One Carrington SSD and Concept Plan (Mod 2)

Attachment A - Response to Department's Key Issues

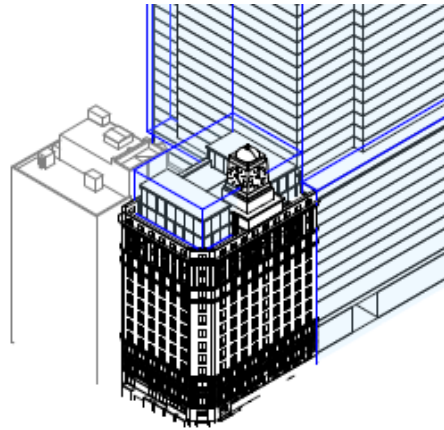
<p>a. a clearer plan of the shared zone including indicative vehicles of a range of sizes and pedestrians;</p>	<p>A clearer plan of the shared zone will be provided at a later stage when approval is sought from RMS. In terms of indicative vehicle size, it is expected that this would vary from an Australian Standard 8.8m long medium rigid truck to a passenger car similar to an Australian Standard 5.2m B99 vehicle or smaller.</p>
<p>b. confirmation that larger service vehicles would be able to manoeuvre around the bollards shown on drawing L-100c; and</p>	<p>The bollards are proposed as a traffic calming measure to slow the travel speed of vehicles travelling along Wynyard Lane as part of the proposed shared zone. The bollards would reduce the road width to approximately 3.0m between the bollards and kerb. Vehicles travelling past the bollards would approach them head on noting that the typical width of a service vehicle is approximately 2.5m. Therefore, vehicles should not have any issues travelling past the bollards.</p>
